PCI Design Handbook

Precast and Prestressed Concrete, Sixth Edition

In 2004, the Precast/Prestressed Concrete Institute published the sixth edition of the PCI Design Handbook—Precast and Prestressed Concrete (MNL-120-04). Although careful efforts were made to provide an accurate document, some errors have been discovered. We suggest that you mark your sixth edition to reflect these errata so that use of the handbook is accurate.

EXAMPLE 6.14.1

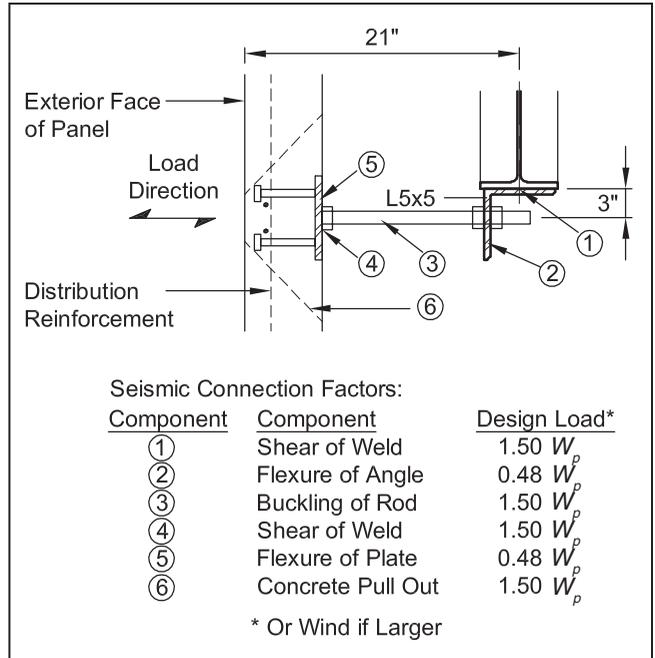
57. Page 6-56: In the right column, fourth line, change the formula to read “0.5V_u/(0.85f_cb)”.
58. Page 6-72: In Example 6.14.1 uses forces determined in Example 3.2.4.2. The seismic force of 3368# already included (in Example 6.14.1) the “0.48W_p” multiplier; therefore, the calculated values presented in the table under the heading “Seismic Design Load” are incorrect. The “5.05 kips” force should be “10.52 kips” and the “1.62 kips” force should be “3.368 kips”. See Appendix B of this document indicates the revisions to the affected values.

Apply connection factors (seismic only) shown at right:

From example 3.2.4.2:

$$0.48 W_p = 3.368 \text{ kip}$$

$$1.5W_p = \frac{1.5}{0.48}(3.368) = 10.52 \text{ kip}$$

$$\text{Factored wind load: } \frac{4184}{1000} = 4.18 \text{ kip}$$

Component	Mode of Failure	Seismic Force	Seismic Design Load	Wind Design Load	Critical Design Load
1	Shear of Weld	$1.50 W_p$	10.52 kip	4.18 kip	10.52 kip
2	Flexure of Angle	$0.48 W_p$	3.37 kip	4.18 kip	4.18 kip
3	Buckling of Rod	$1.50 W_p$	10.52 kip	4.18 kip	10.52 kip
4	Shear of Weld	$1.50 W_p$	10.52 kip	4.18 kip	10.52 kip
5	Flexure of Plate	$0.48 W_p$	3.37 kip	4.18 kip	4.18 kip
6	Flexure of Pullout	$1.50 W_p$	10.52 kip	4.18 kip	10.52 kip

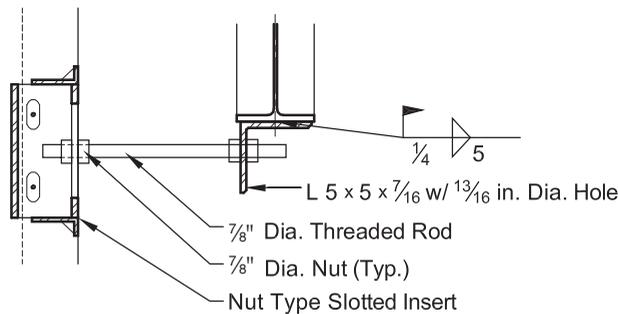
63. Pages 6-97 thru 6-101: The values in Table B are incorrect; the second term of Equation 6.5.4.3 was not included. See Appendix C for corrected values.

$$\phi N_{cb} = C_{bs} A_N C_{crb} \Psi_{ed,N}$$

$$\Psi_{ed,N} = 1.0$$
